PETITIONER'S APPLICATION - ARLINGTON HEIGHTS PLAN COMMISSION

PLAN COMMISSION PC #15-002
Northwest Metalcraft
413 S. Arlington Heights Road
PUD Amendment
Round 1

Round 1 Review Comments

Planning Department Comments, Northwest Metalcraft (PL15-002, 413 S. Arlington Heights Road, Round 1)

Village of Arlington Heights Tower 131

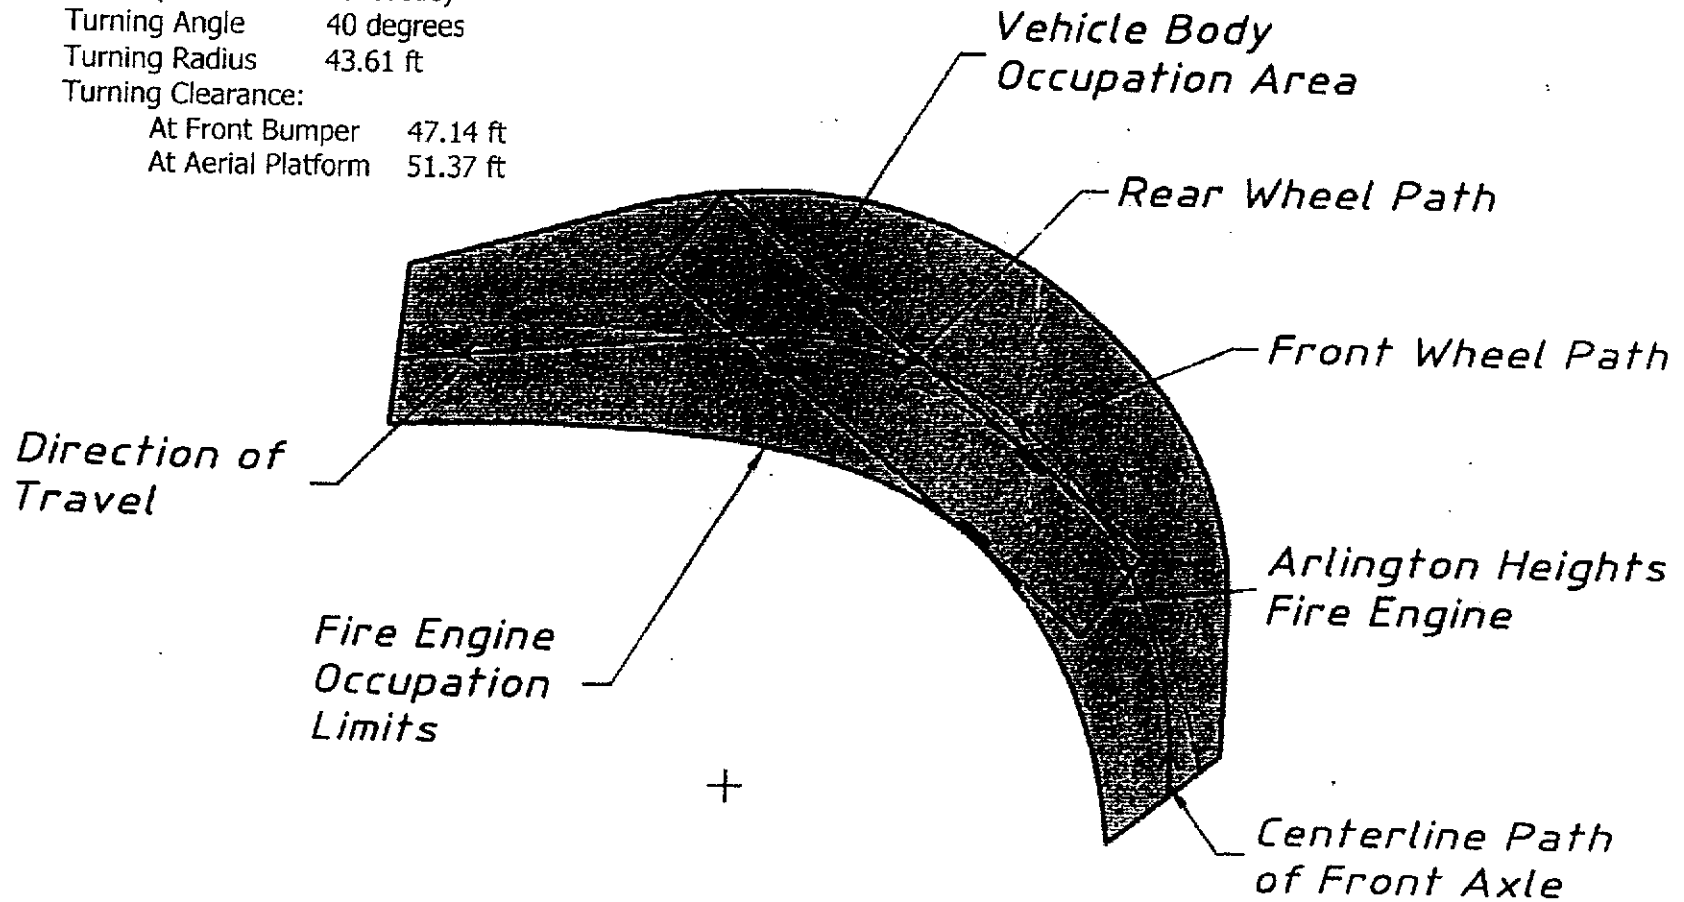
15. Provide an exhibit to engineering scale showing the turning path of the Fire Department's responding vehicle, in this case the tower truck. Exhibit must show front and rear wheel paths and the extent of the front and rear overhangs, as provided in an "Autoturn" exhibit. The vehicle shall be shown maneuvering through the site in all possible directions of travel. Attached are the specifications for the tower apparatus. Attention shall be given to the sweep of the vehicle overhangs when cross referenced to the landscape plan.
